SKILLING, HELLE, CHRISTIANSEN, ROBERTSON — Structural & Civil Engineers

PROJECT: THE WORLD TRADE CENTER | TITLE: K1 EL.310 REPAIR DETAIL FOR EXISTING STEEL | DATE: 6-12-72

Detail F5

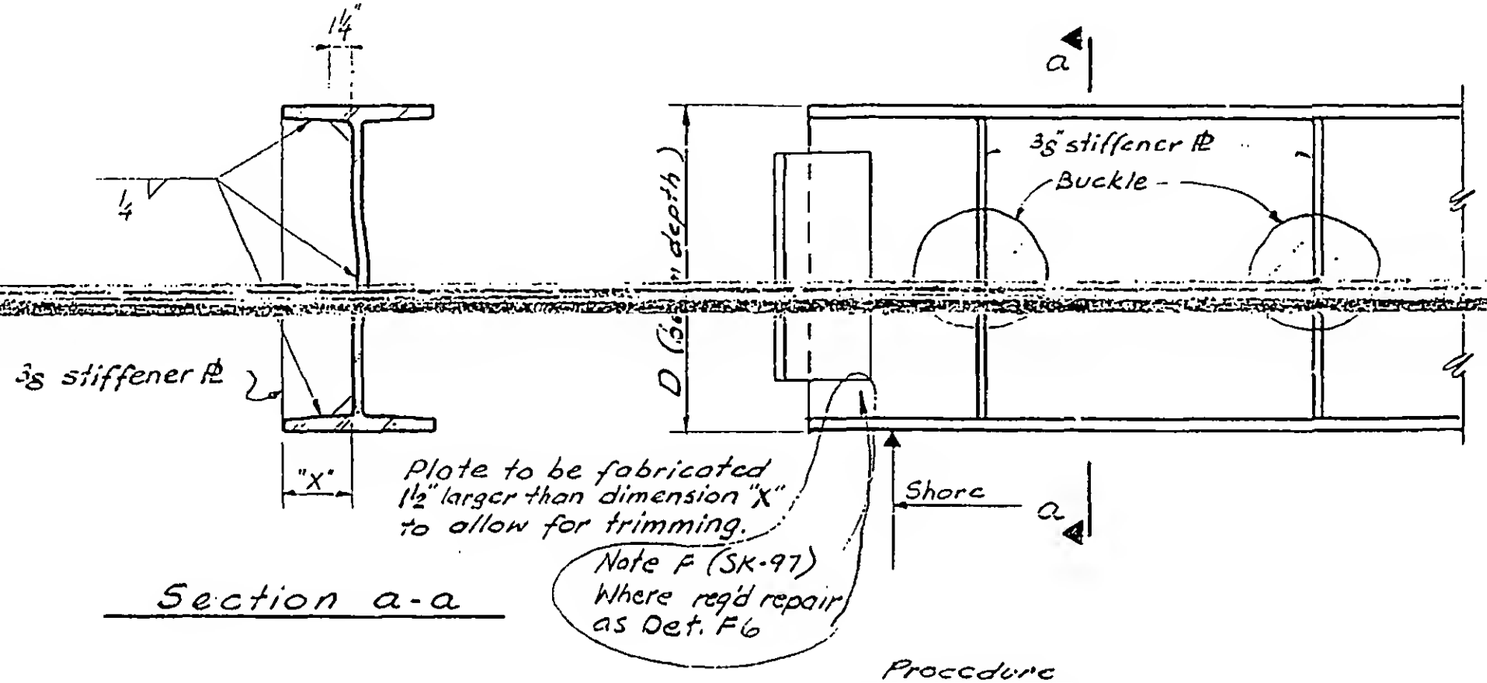
Buckled web 2 locations & failed connection

1. Shore beam
2. Remove damaged connection
3. Replace with same type connection, but capacity to be as shown in Plan
4. Trim vertical stiffener plates to fit and install as shown.
5. Remove shores.
